City of Oakley
ADDENDUM NO. 1 to contract documents for
OAKLEY RECREATION CENTER PROJECT
CIP # 194

BID OPENING DATE: March 8, 2018 at 2:00pm

Notice is hereby given that the following clarifications and revisions are made to the above referenced contract documents:

Drawing Number:
C5.0

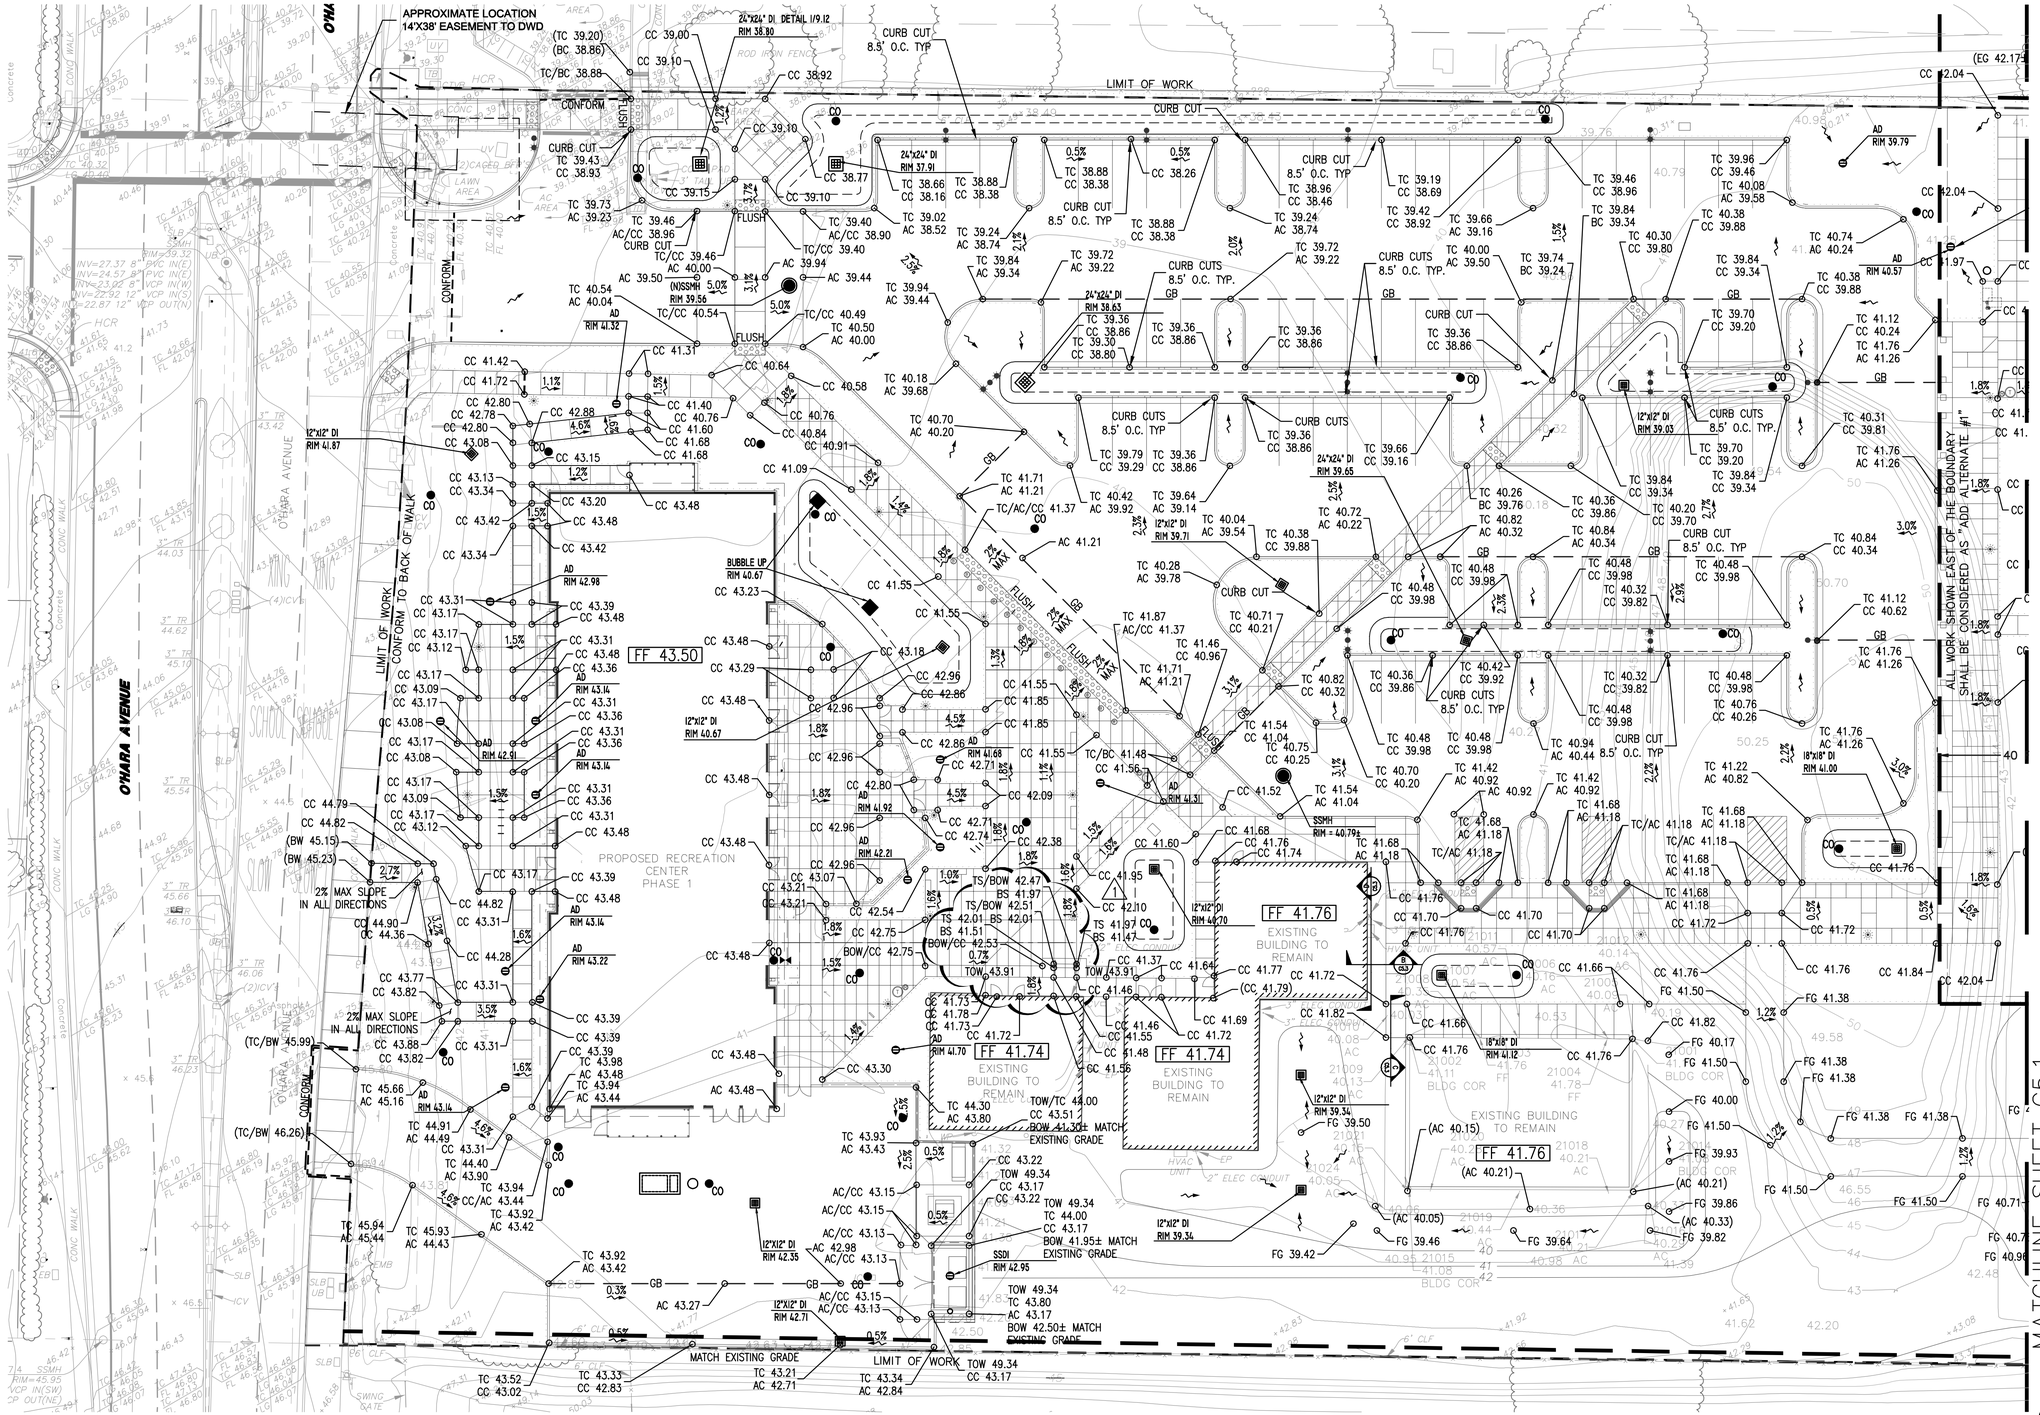
C5.0 1. The elevations at the stairs leading to the existing building were adjusted to match the latest site plan. See attached full sheet C5.0.

2 A9.7 RESTROOM COUNTER SECTION

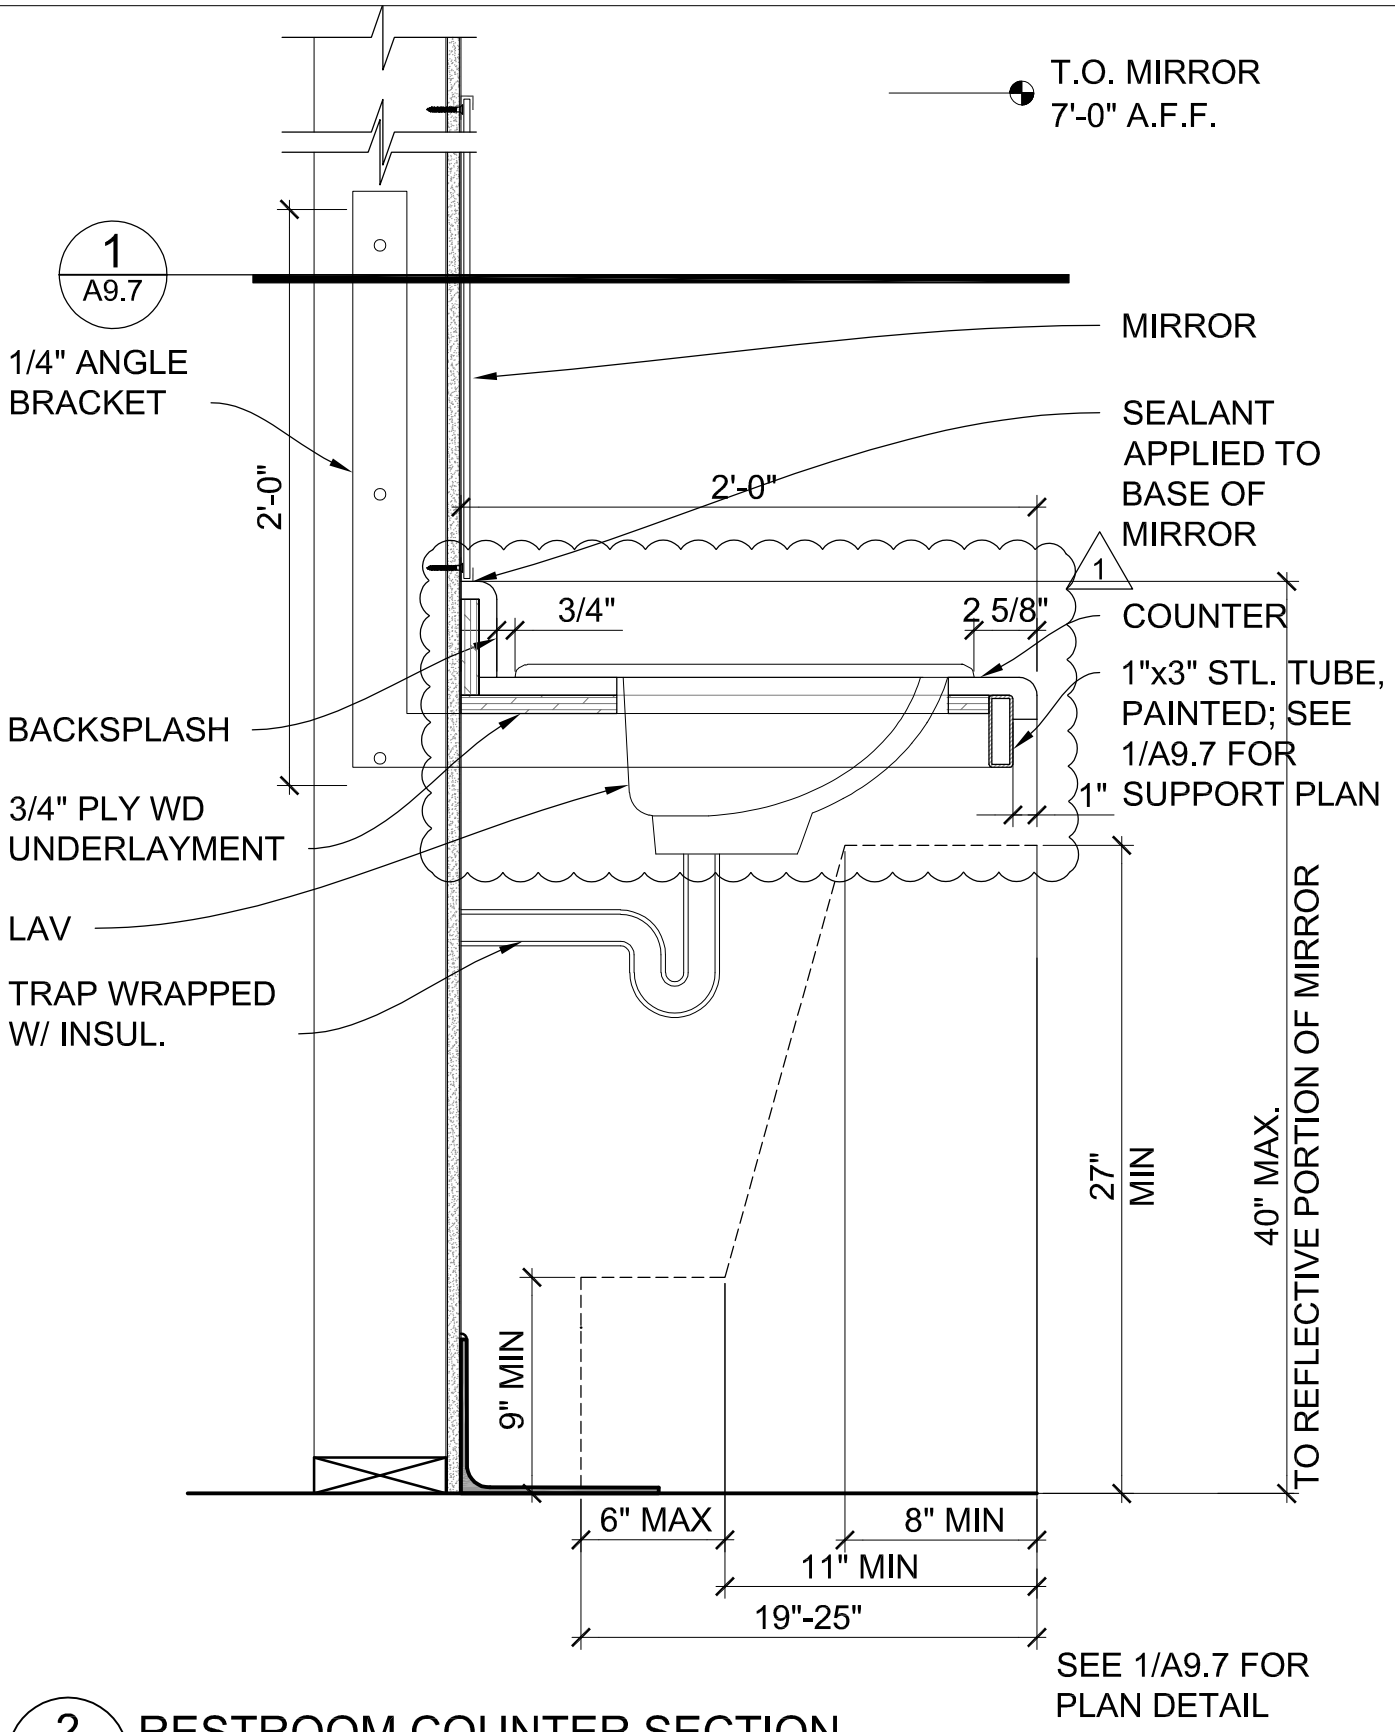
A9.7 1. Detail 2 revised to indicate drop in lavatory. See ASK-01.

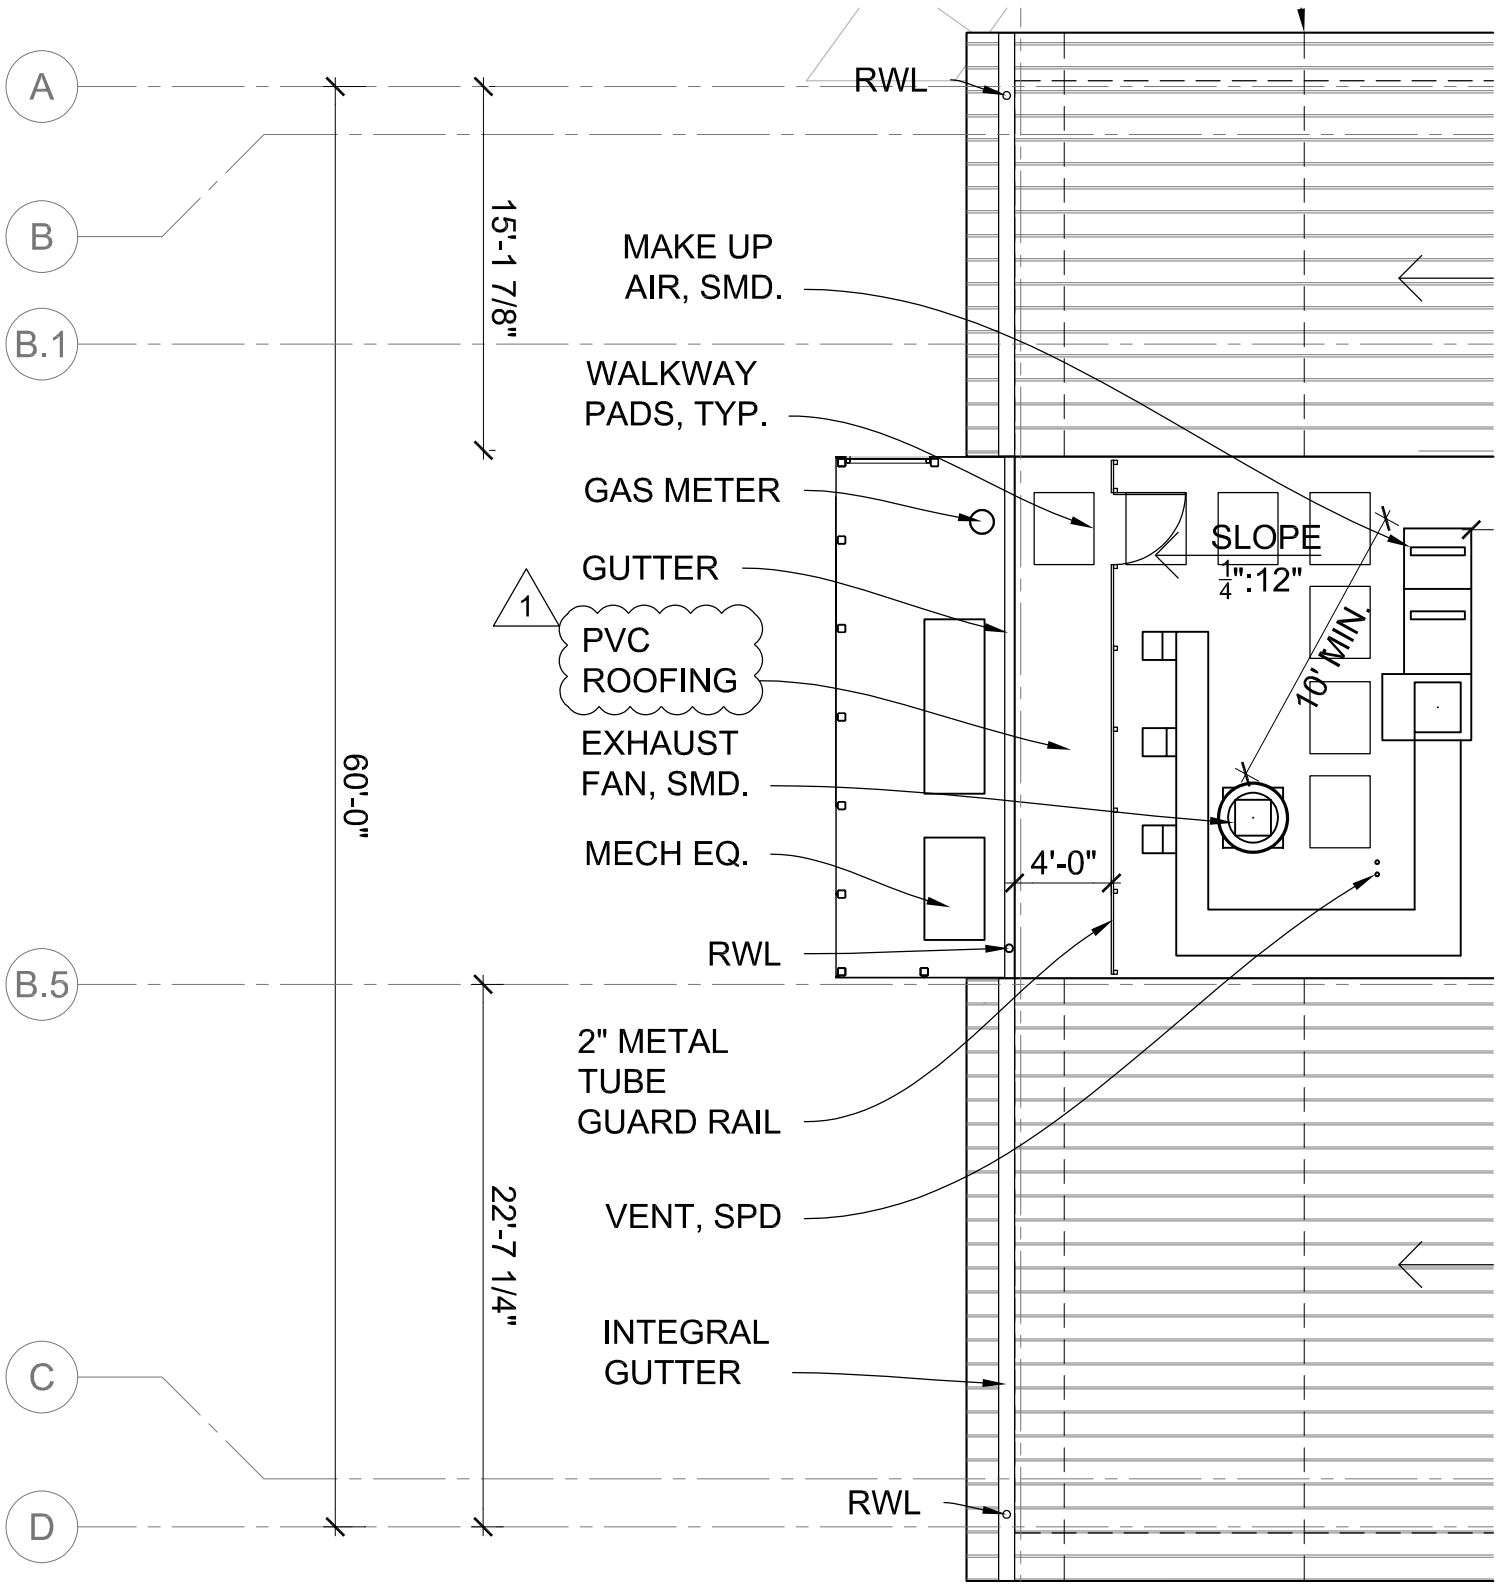
A2.3 1. Revise roofing note to indicate PVC roofing per attached ASK-02a.

3 / A8.3 FLAT ROOF AT WALL

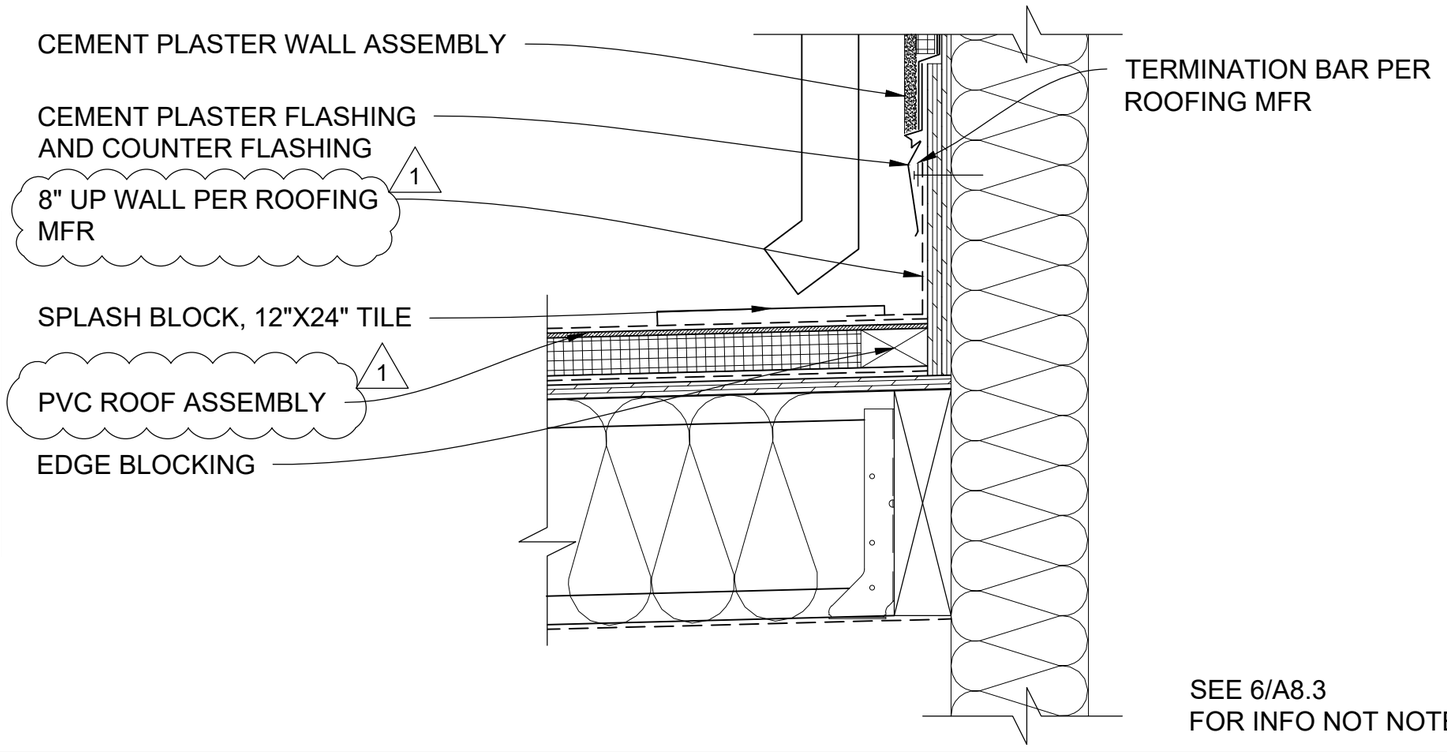
A8.3 1. Revise roofing note on detail 3/A8.3 to indicate PVC roofing per attached ASK-02b.
2. Revise roofing note on detail 8/A8.3 to indicate PVC roofing per attached ASK-02b.

Drawing Number:
E2.1

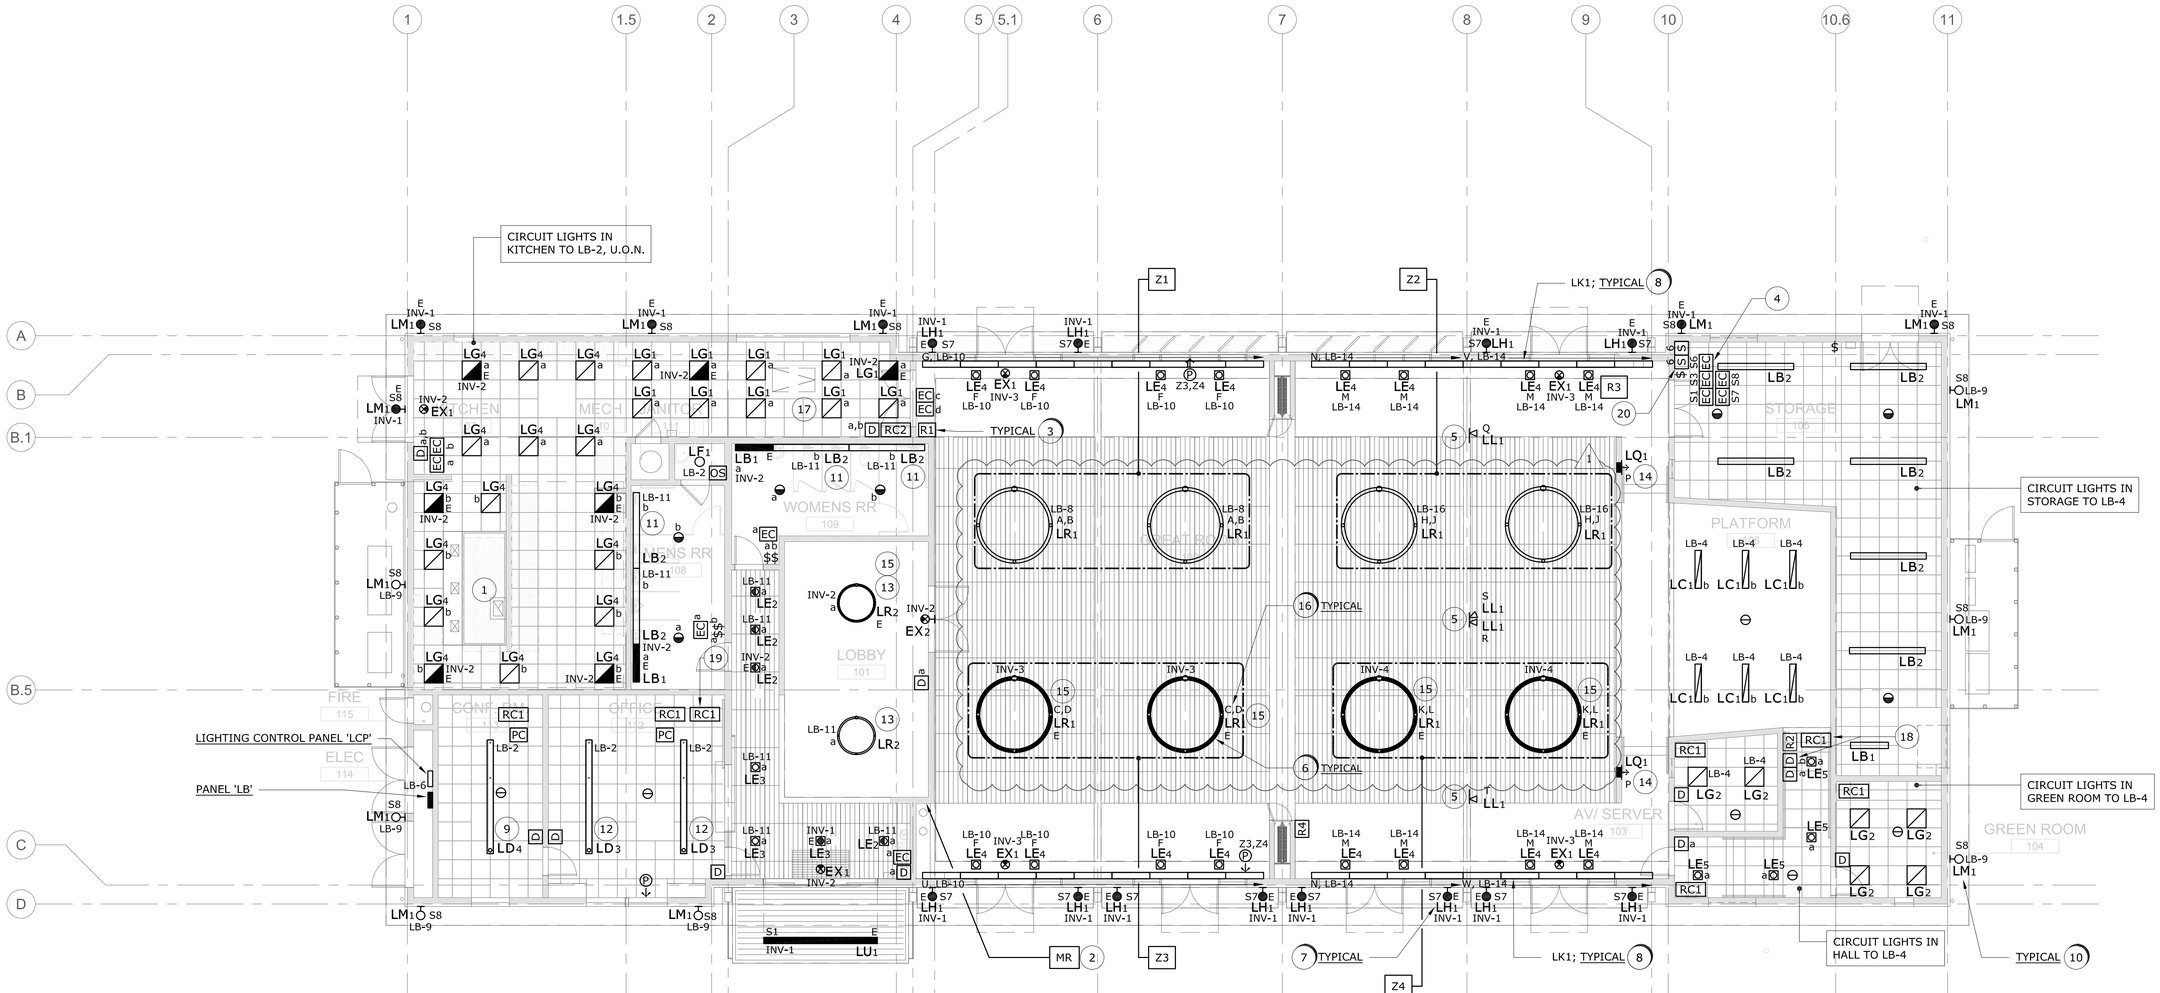
E2.1 1. Revise size of fixture LR1 as indicated. See attached full sheet E2.1.
